TOWN OF LEDYARD CONNECTICUT

Permanent Municipal Building Committee

III. UPDATE ON JULIET W. LONG HVAC PROJECT

Juliet W. Long HVAC Improvements

SKA-02

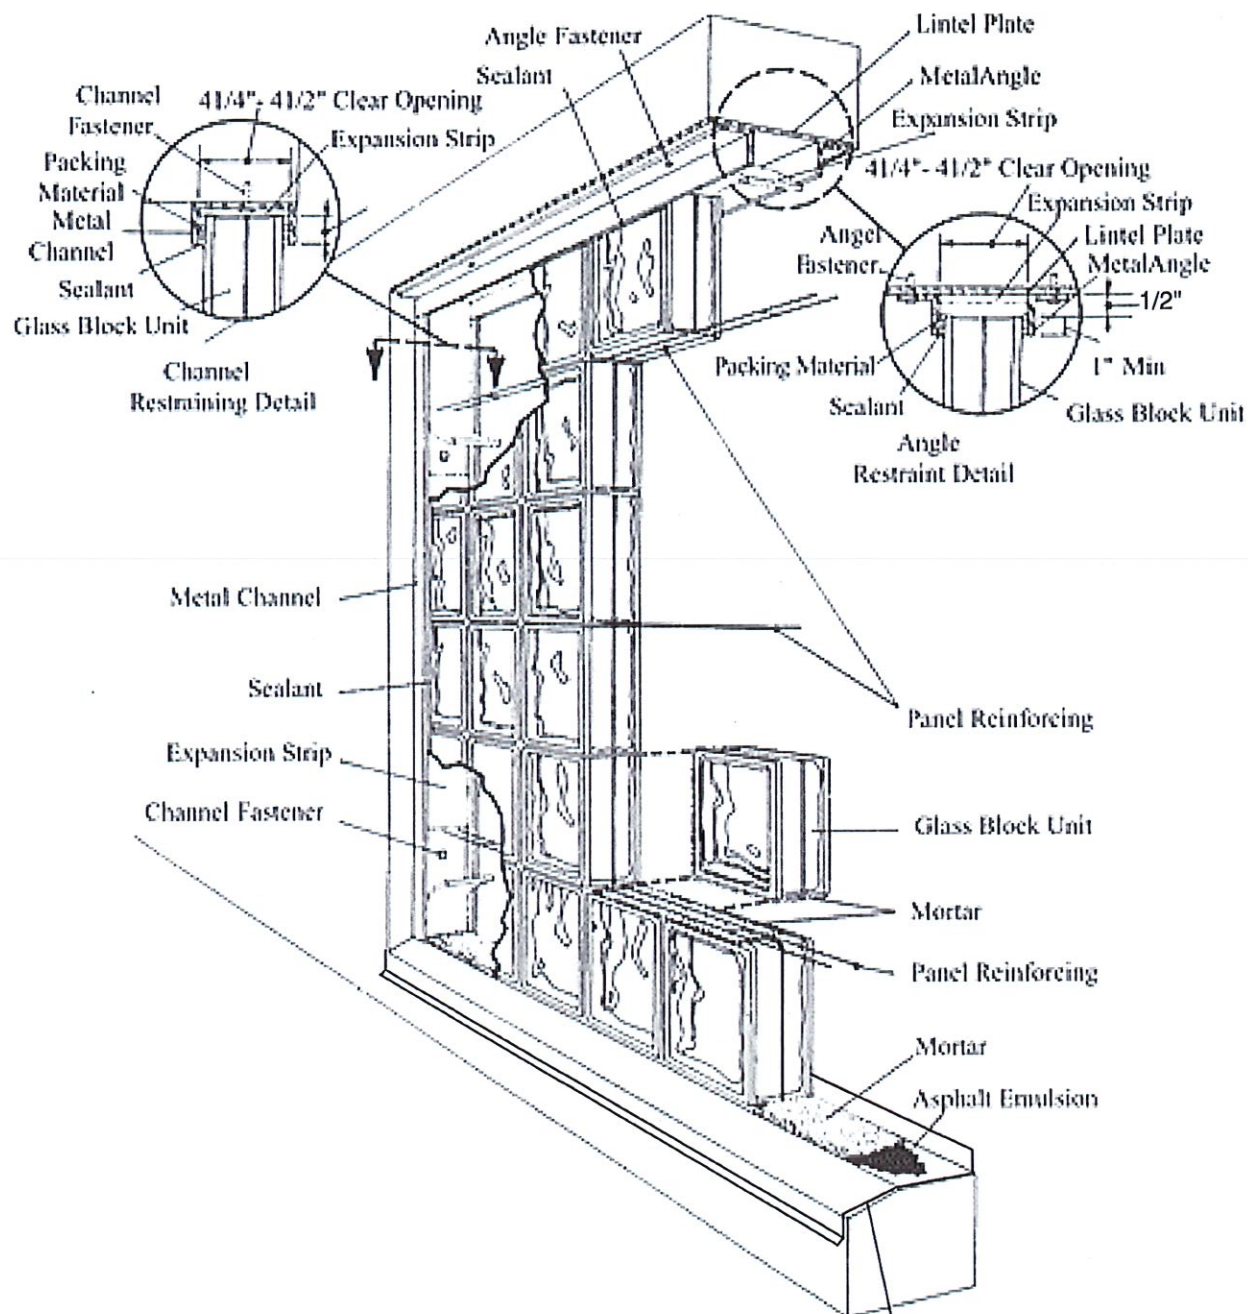
Per Nutmeg Companies, Inc. PCO #04 Credit for metal panel infill, install glass block at GYM. Dated 6/18/2026, credit metal panel material and labor for louver infills, and provide glass block infill per SKA-02.

DESCRIPTION OF PROPOSAL: in lieu of providing metal panel infill at the removed GYM louver and hood we propose a credit to infill the openign with Glass Block

DESCRIPTION OF PROPOSAL: Infill existing framed louver openings at the gym with glass block.

Provide stainless steel thru-flashing with drip edge and end-dams with 1/2" min. vertical leg on interior face. Flashing to be set in bed of sealant or asphalt emulsion.

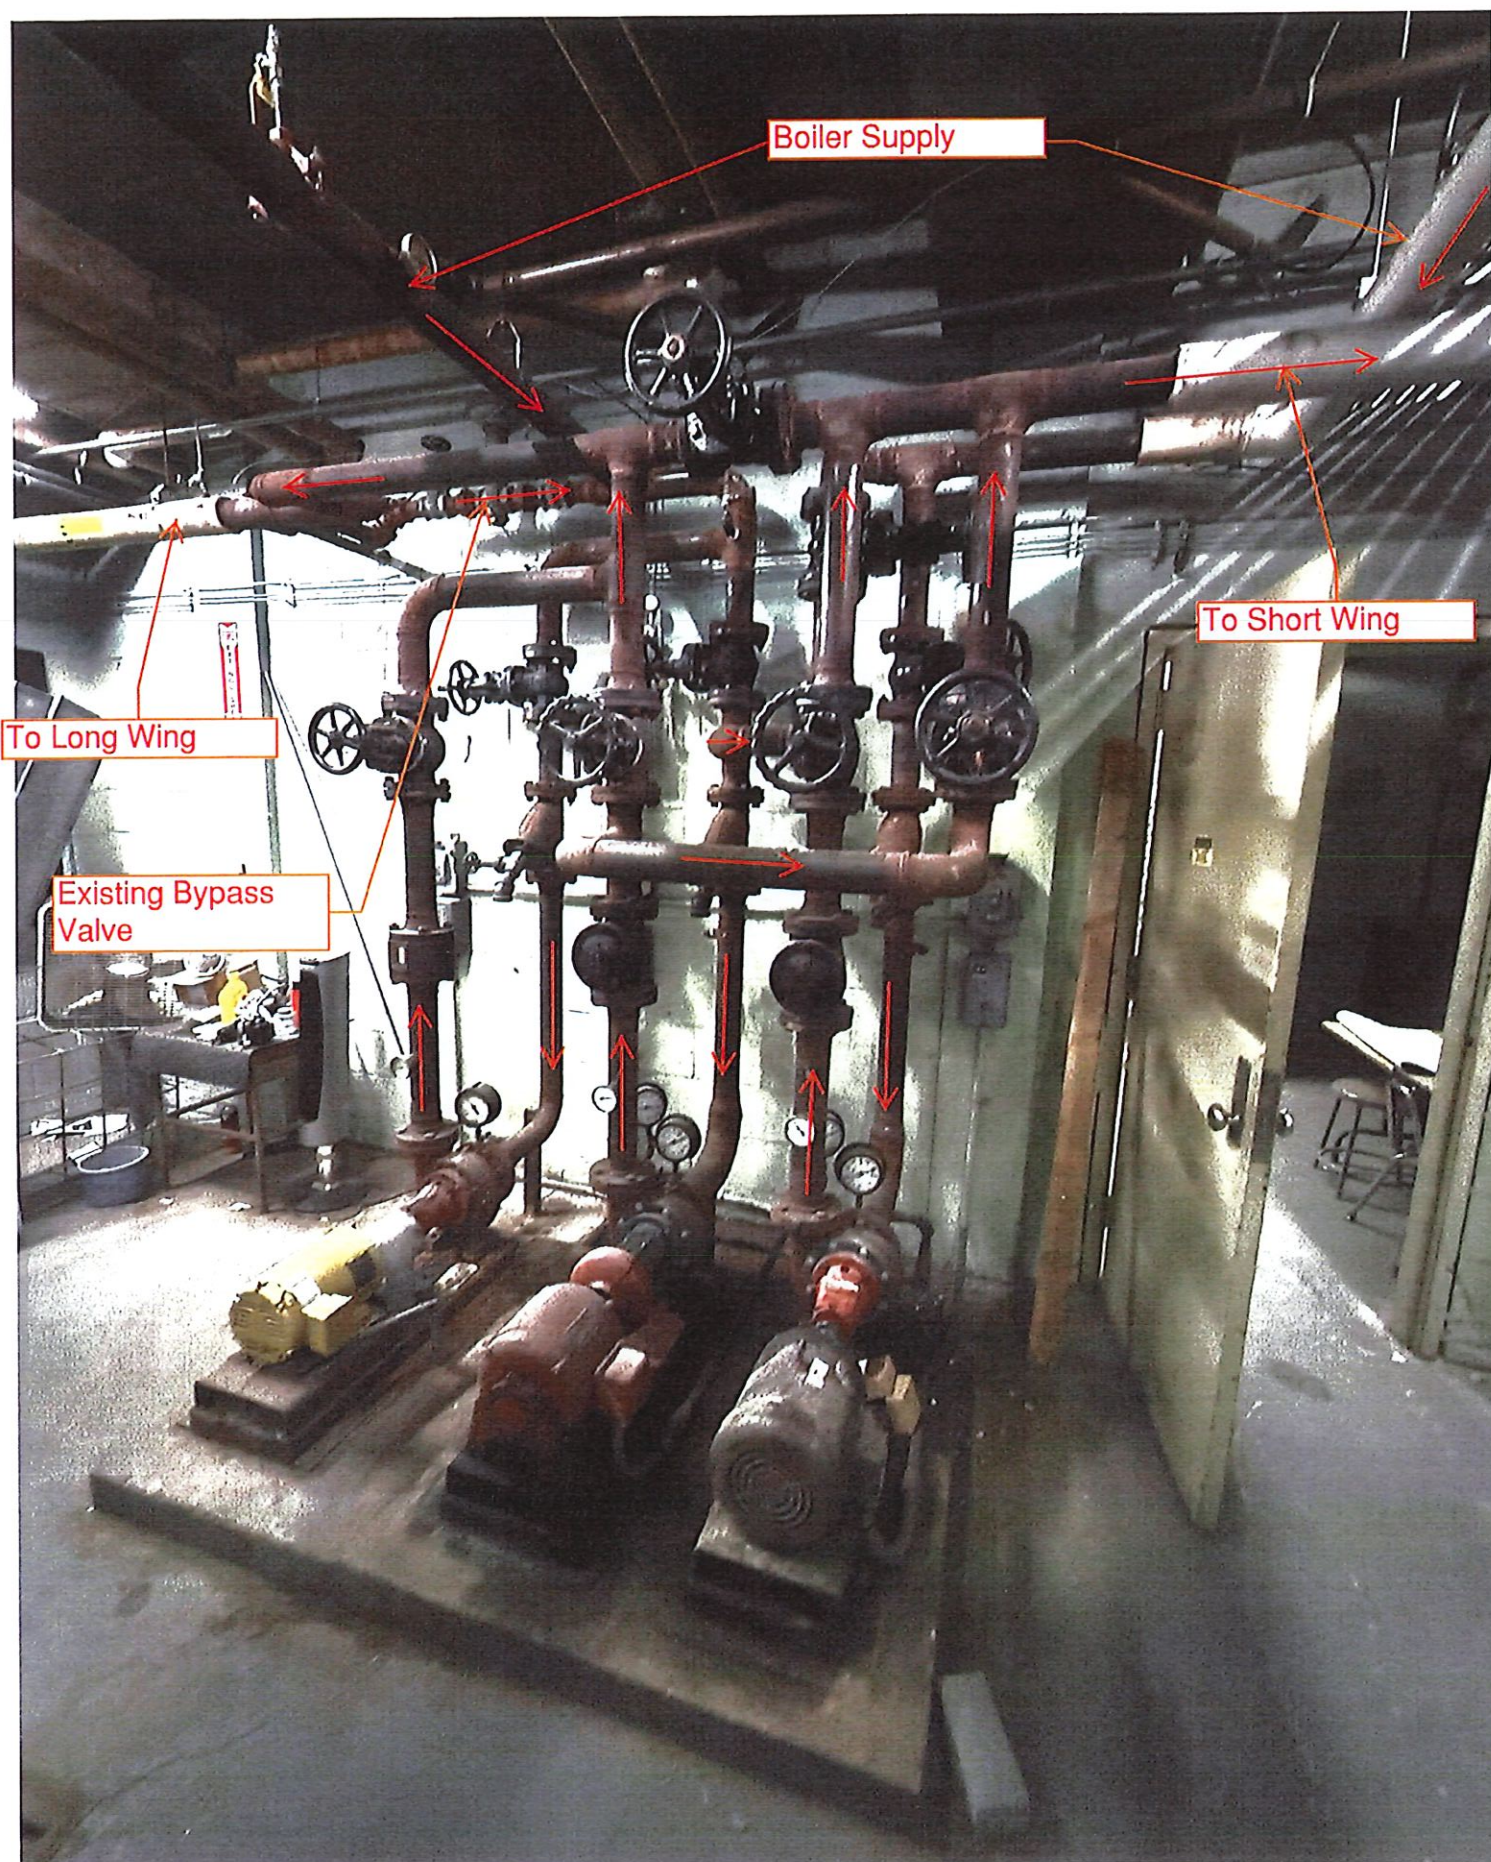
The single bypass valve at the pumps appears to only be for the Long wing (depending on valving), the short wing does not have a separate bypass. If the valves that interconnect the long and short wings are normally closed there is no bypass for the short wing. (see attached picture)

Please advise if there are any changes necessary to the valves, piping or pumps

Add new 2" bypass & modulating control valve on the short wing pumping circuit which will be controlled

by new DP sensor (same as long wing). Jon Petersen - VZHS 3/2/26
